All EZGas Pro burners manufactured before date 06-01-2019 are equipped with a harness for a Honeywell gas valve. The following are steps to retrofit the existing Honeywell harness to the White Rogers valve in this kit.

# White Rogers Gas Valve Retrofit

## for EZGas Pro Supplement

### Option 1

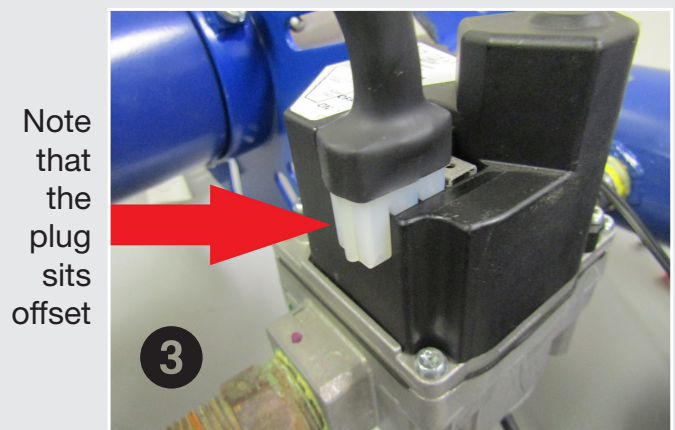
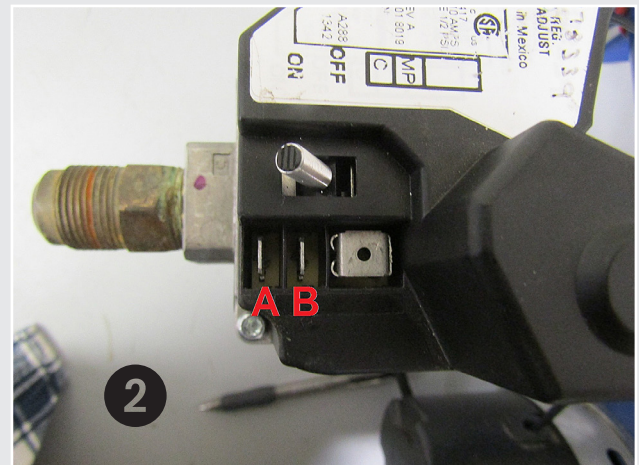
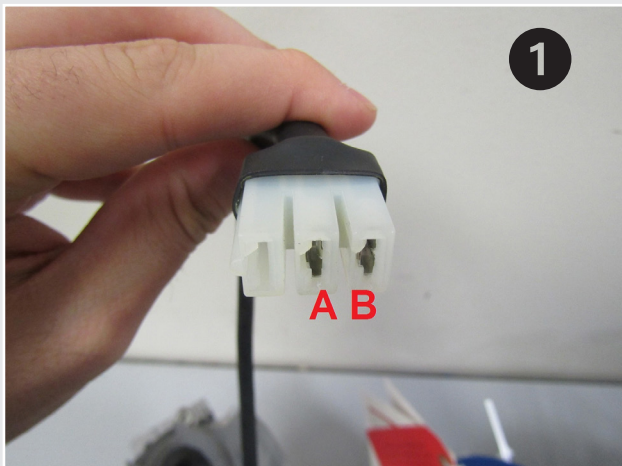
Plug the existing Honeywell harness **1** into the compatible slots on the White Rogers valve **2**. Note that plug will sit offset. The offset section is empty and contains no wiring **3**.

Note that the plug sits offset

### Option 2

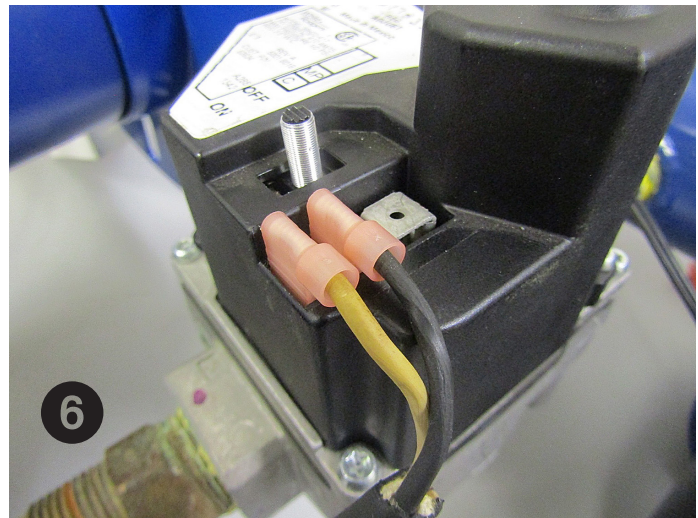
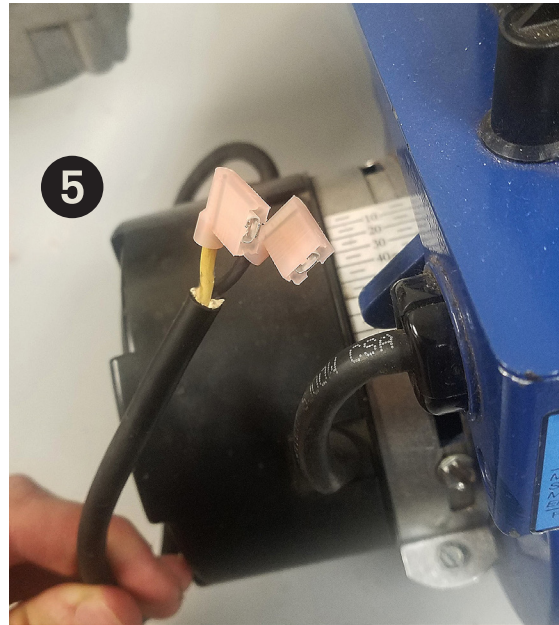
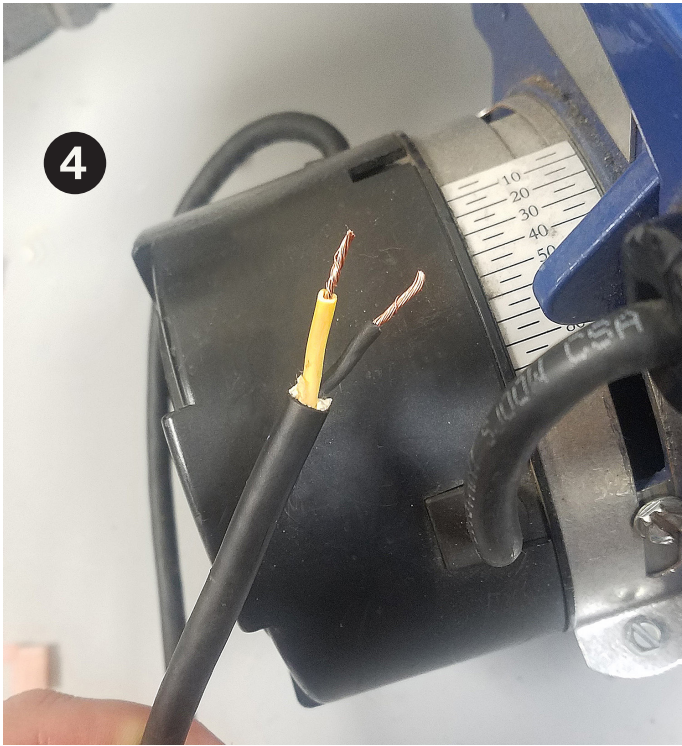
Strip the Honeywell harness off the existing wire ④. Add compatible flag terminals to the now stripped wire ⑤. Connect to White Rogers valve ⑥.
